ALERT SERVICE BULLETIN

505-20-17

MODEL AFFECTED: 505

SUBJECT: FLAP RESTRAINT SUPPORT P/N 206-010-181-101,
ONE-TIME INSPECTION OF

FIGURE 1 – Flap Restraint Support Surface Contact Area

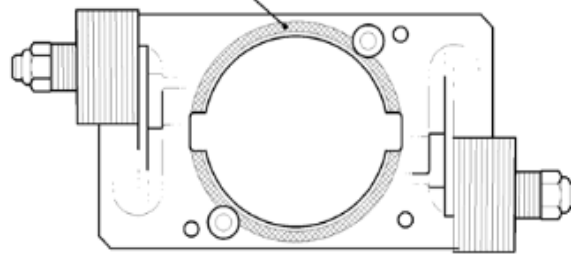
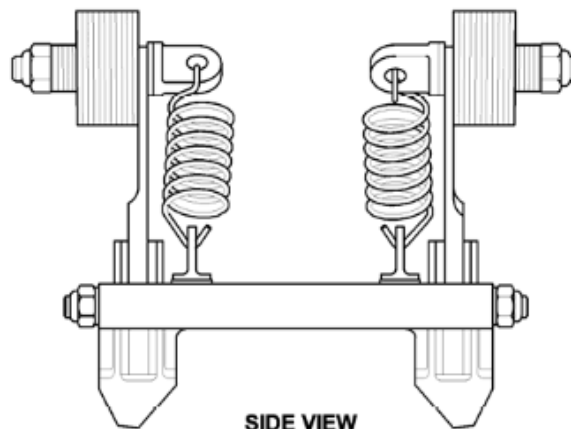
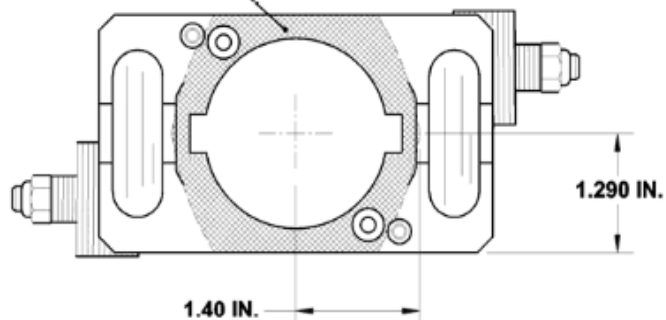
2. Remove the flap restraint assembly [DMC-505-A-62-20-02-00A-520A-A](#).
3. Inspect the flap restraint support surfaces in contact with the mast nut and the main rotor trunnion for presence of clear coat (Figure 1). Clear coat is not acceptable at the areas shown.

PRIMER ONLY ON SURFACE IN CONTACT
WITH MAST NUT FOOT PRINT

PRIMER ONLY ON SURFACE
IN CONTACT WITH TRUNNION

- a. If **no** clear coat is found overlaying the primer (Figure 2), go to step 4.
 - b. If clear coat **is found** overlaying the primer (Figure 2), remove the clear coat as follows;
 - (1) Remove clear coat by sanding using 180 grit abrasive paper (C-423) and wiped clean with solvent. Some amount of clear coat may be removed with cheese cloth (C-486) soaked with MEK (C-309) or equivalent solvent.
4. Install the flap restraint assembly [DMC-505-A-62-20-02-00A-720A-A](#).
 5. Make an entry in the helicopter logbook and historical service records indicating findings and compliance with this Alert Service Bulletin.
